# UNIVERSITY OF KENTUCKY Purchasing Division

CCK-2632-22

ADDENDUM# 2

**UK Reynolds Building #1 College of Design  
BID PACKAGE - 01  
ADDENDUM No. 2  
CCK-2632-22  
05/25/2022**

**EP-100B**

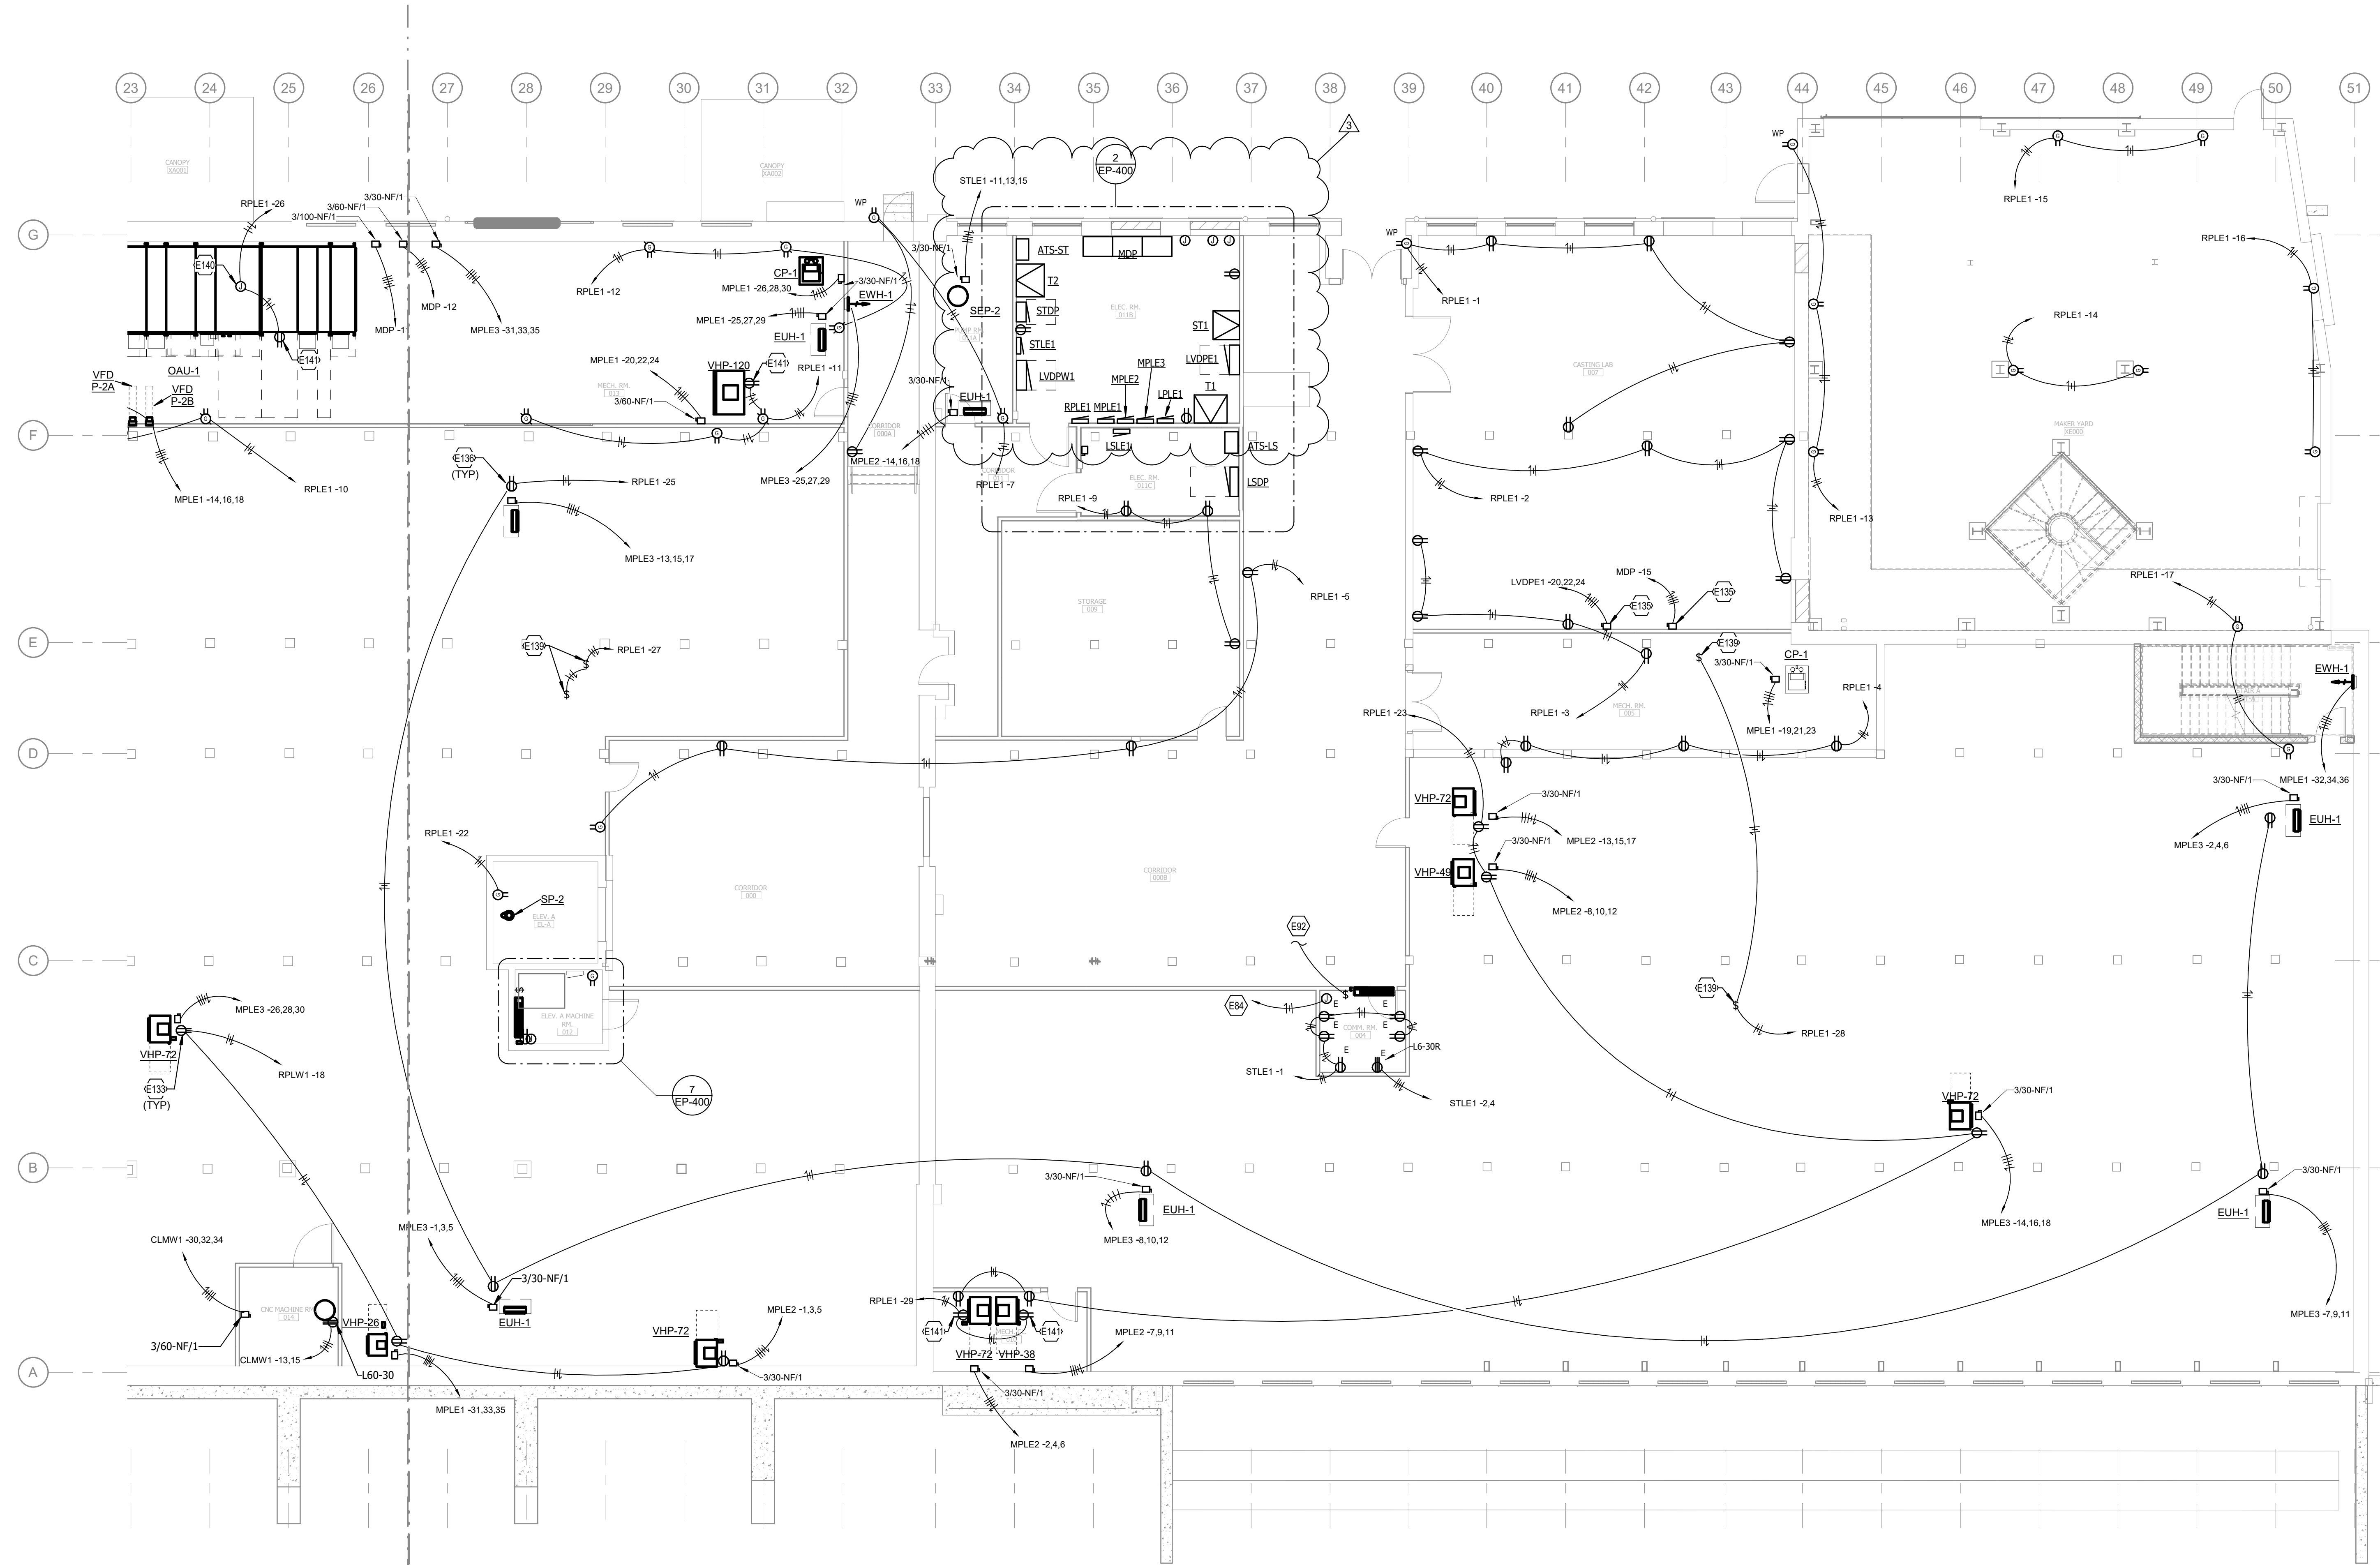
Item #20 Refer to the Electrical Drawing, sheet EP-100B – Lower Level East – Power Plan

**EP-600**

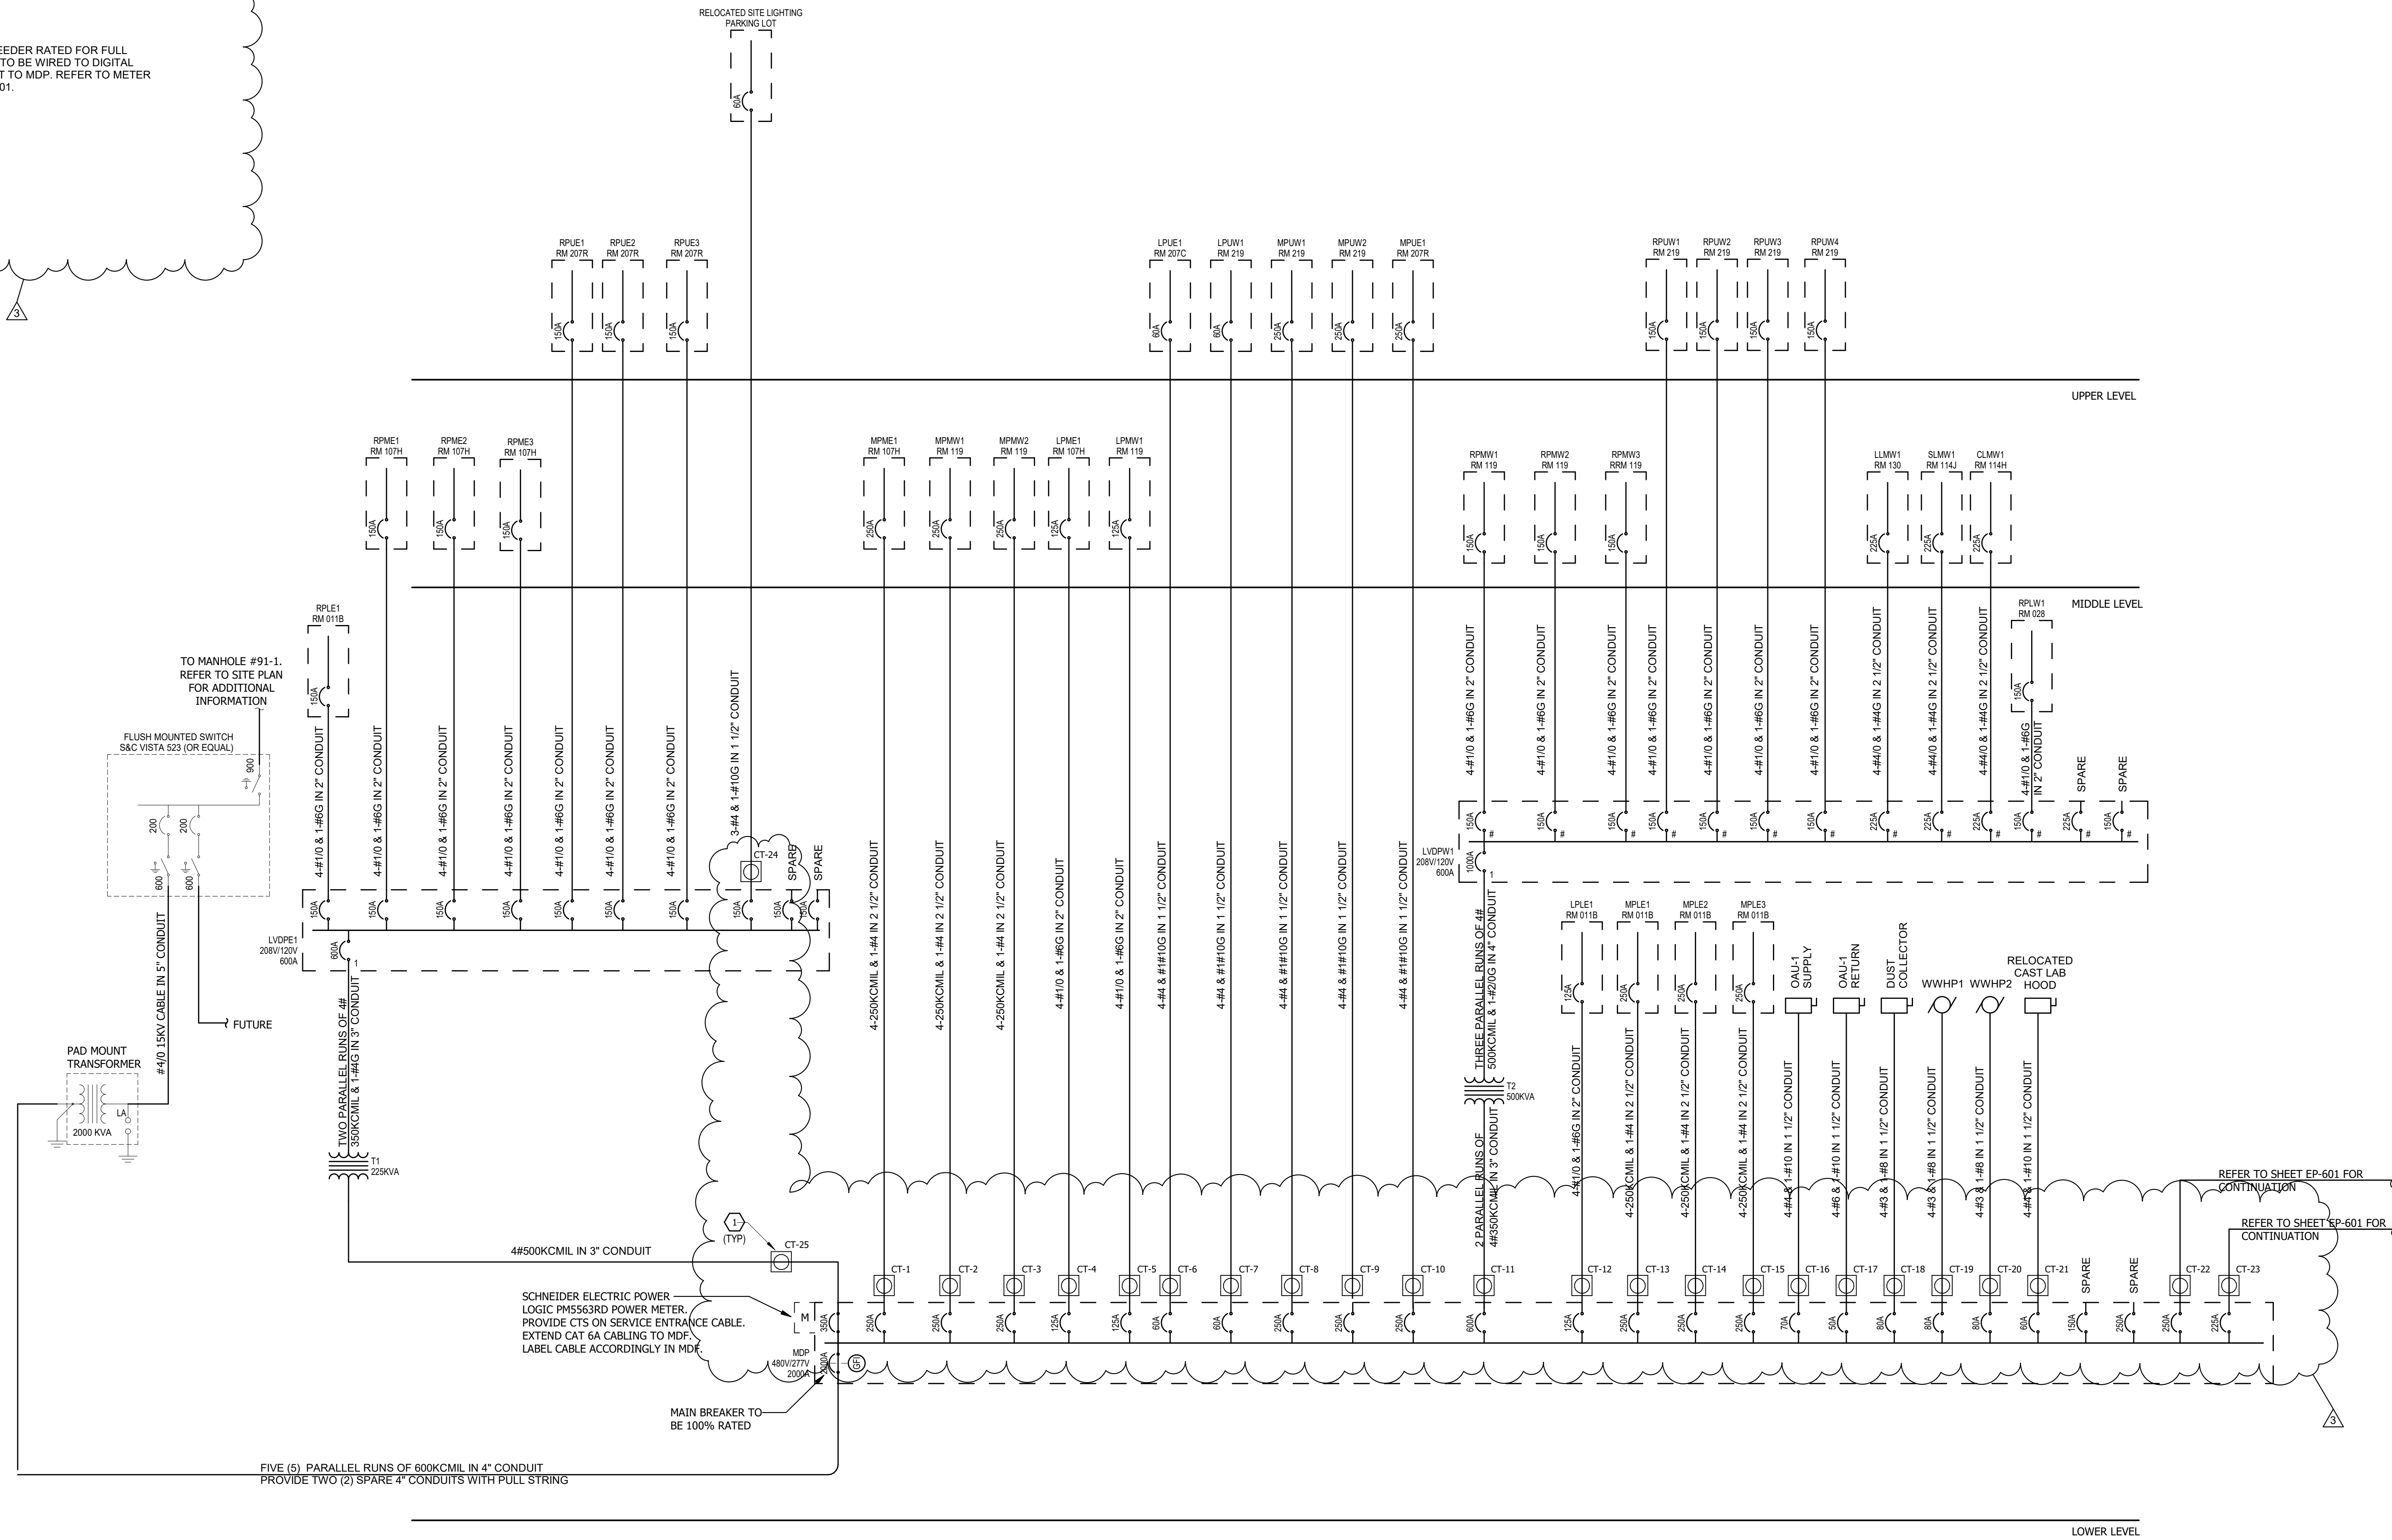
Item #23 Refer to the Electrical Drawing, sheet EP-600 – Electrical One-Line

**EP-601**

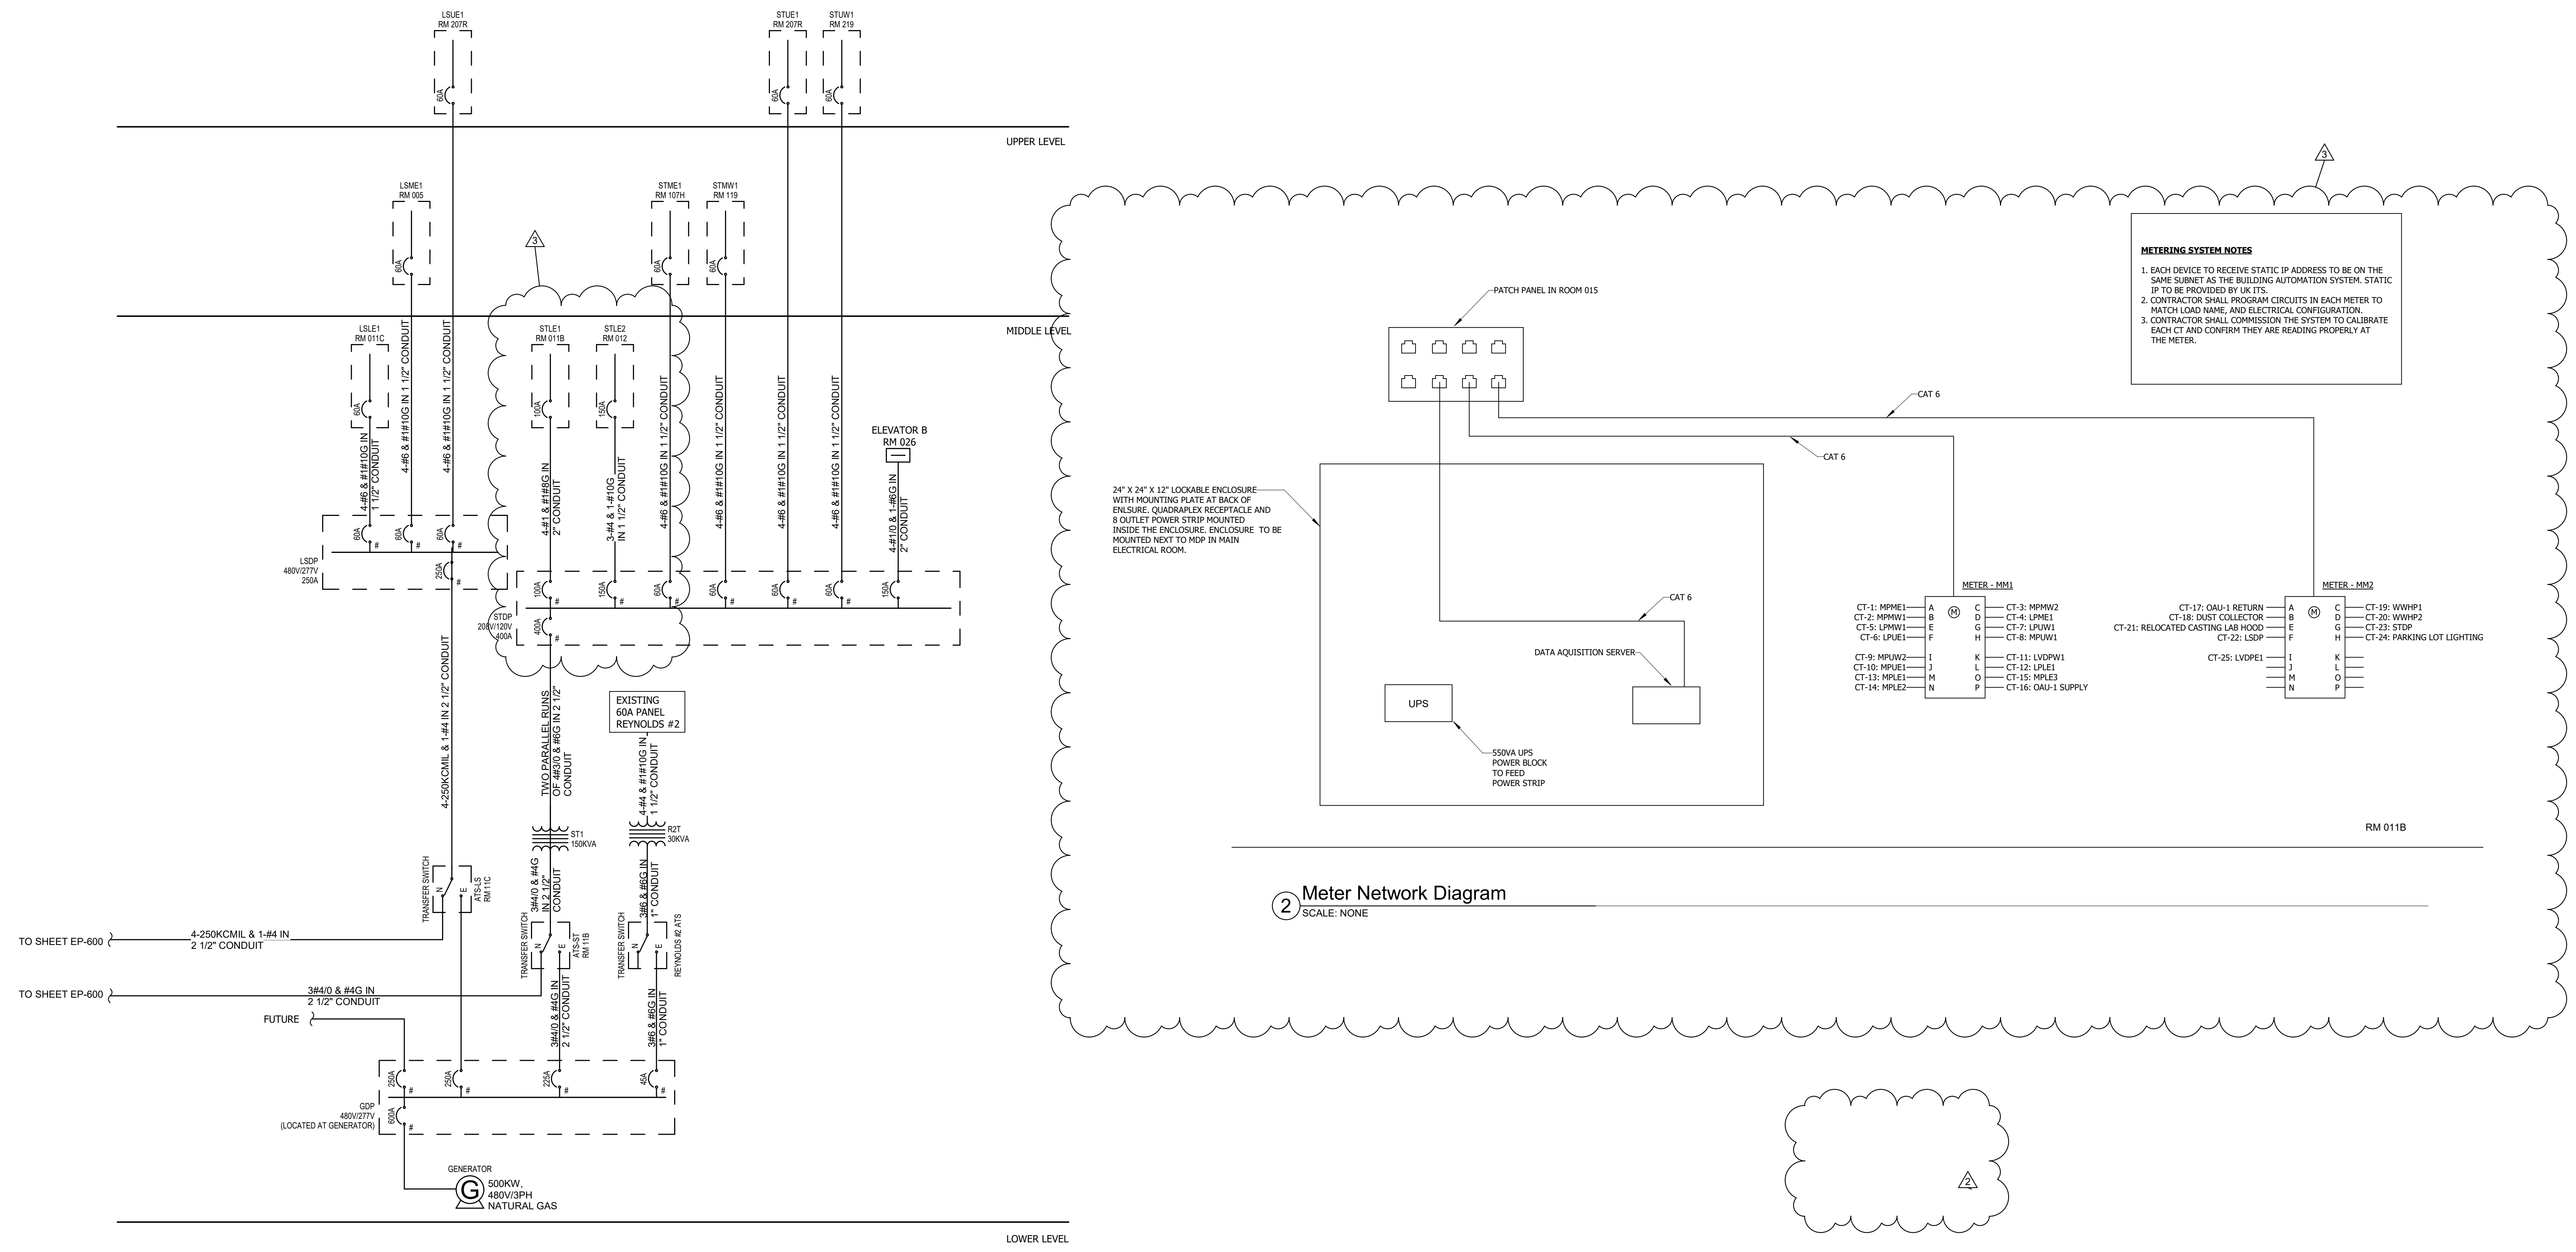
Item #24 Refer to the Electrical Drawing, sheet EP-601 – Electrical One-Line
